TRANS/WP.29/629  
2 June 1998

**DRAFT 01 SERIES OF AMENDMENTS TO REGULATION No. 63**

(Noise of mopeds)

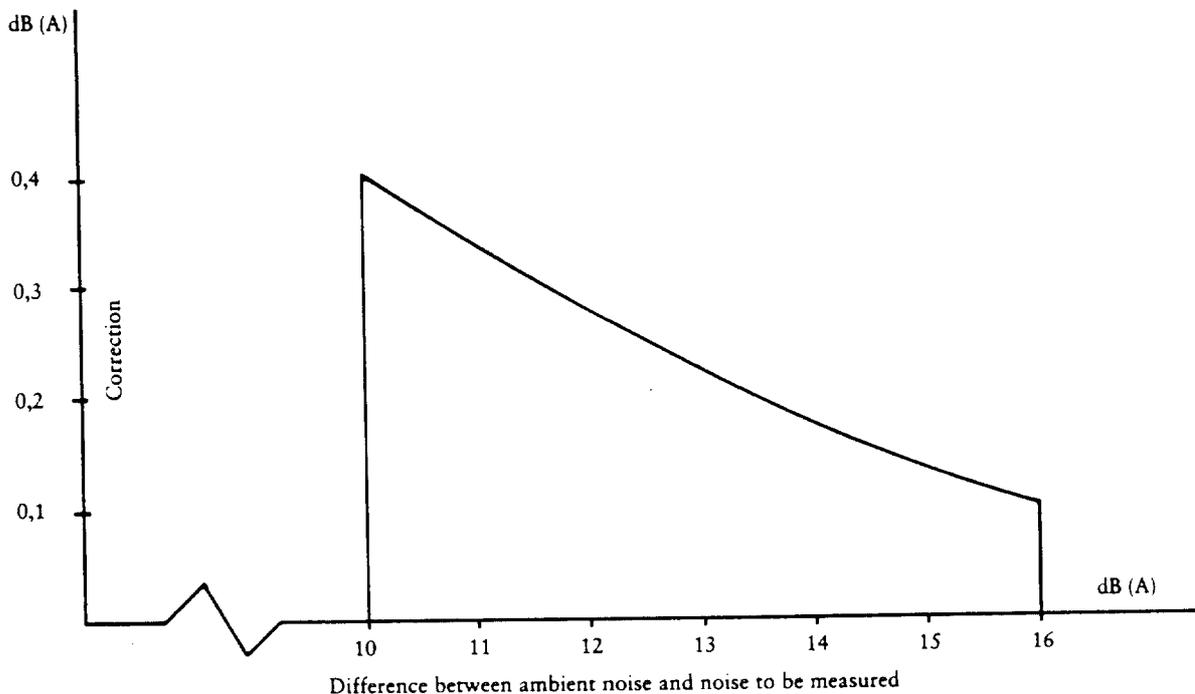
If the difference between ambient and measured noise-levels is between 10 and 16 dB(A), the appropriate figure shall be subtracted from the value recorded by the sound-level metre, in accordance with the following graph:

Figure 3

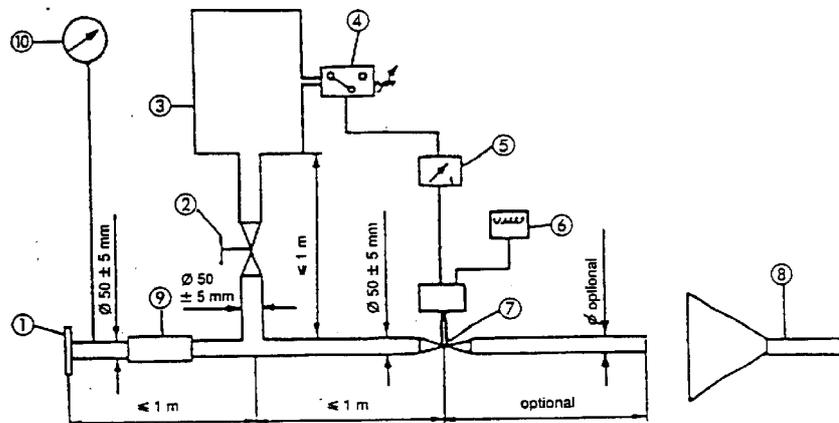
Insert a new figure 3 as follows:

"TEST APPARATUS FOR CONDITIONING BY PULSATION

Figure 1:  
Minimum  
requirements

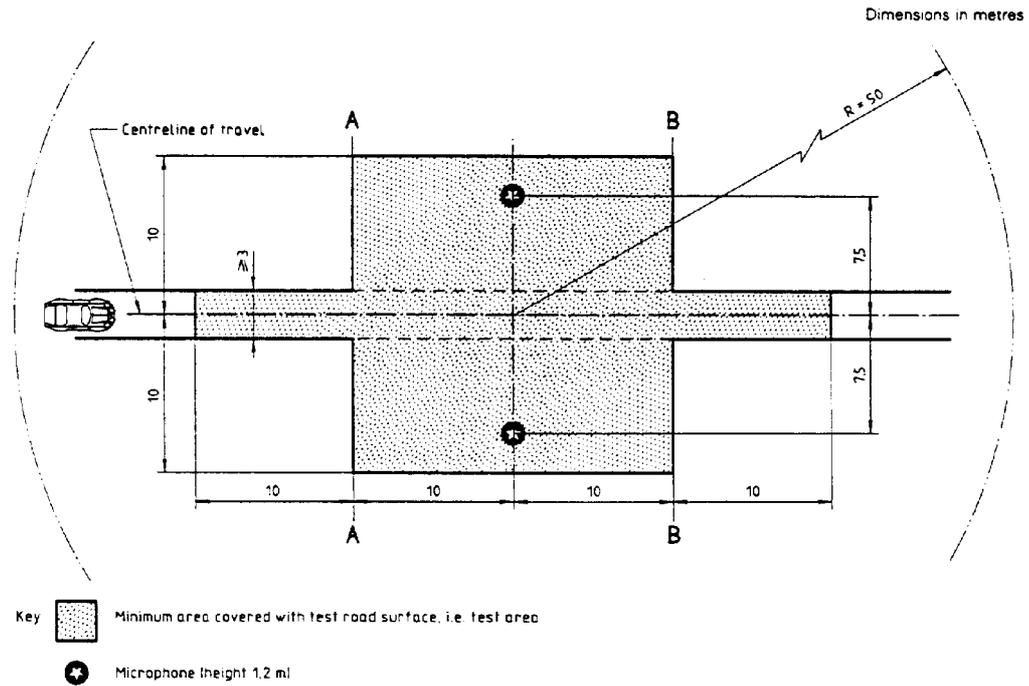
When designing the test track layout it is important to ensure that, as a minimum requirement, the area traversed by the vehicles running through the test strip is covered with the specified test material with suitable margins for safe and practical driving. This will require that the width of the track is at least 3 m and the length of the track extends beyond lines AA and BB by at least 10 m at either end. Figure 1 shows a plan of a suitable test site and indicates the minimum area which shall be machine laid and machine compacted with the specified test surface material. According to annex 3, paragraph 3.1.1.1., measurements have to be made on each side of the vehicle. This can be made either by measuring with two microphone locations (one on each side of the track) and driving in one direction, or measuring with a microphone only on one side of the track but driving the vehicle in two directions. If the former method is used, then there are no surface requirements on that side of the track where there is no microphone.

NOTE — There shall be no large acoustically reflective objects within this radius.

Figure 2: Grading curve of the aggregate in the asphaltic mix with tolerances.

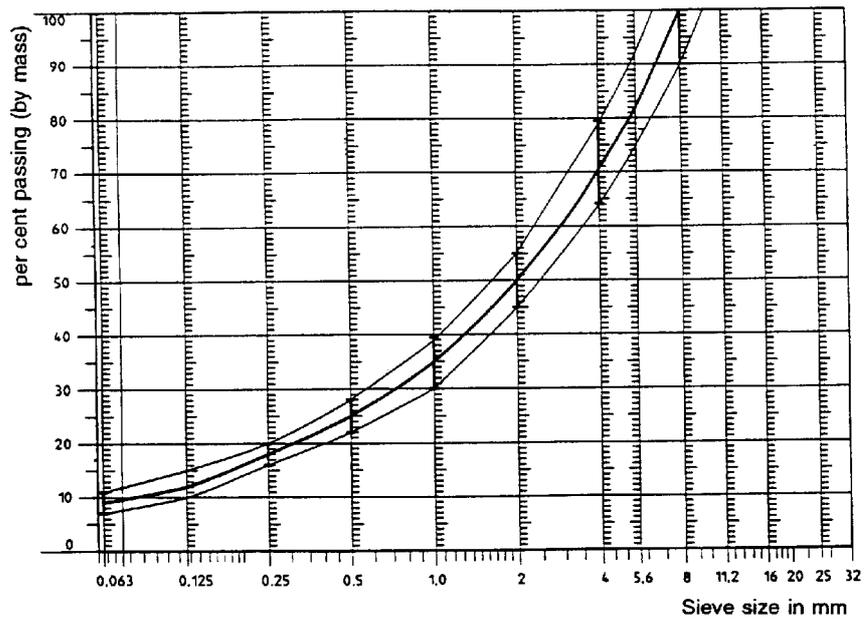
As a guide to the surface constructor, an aggregate grading curve which will give desired characteristics is shown in Figure 2. In addition, Table 1 gives some guidelines in order to obtain the desired texture and durability. The grading curve fits the following formula:

$$P (\% \text{ passing}) = 100 \cdot (d/d_{\max})^{1/2}$$
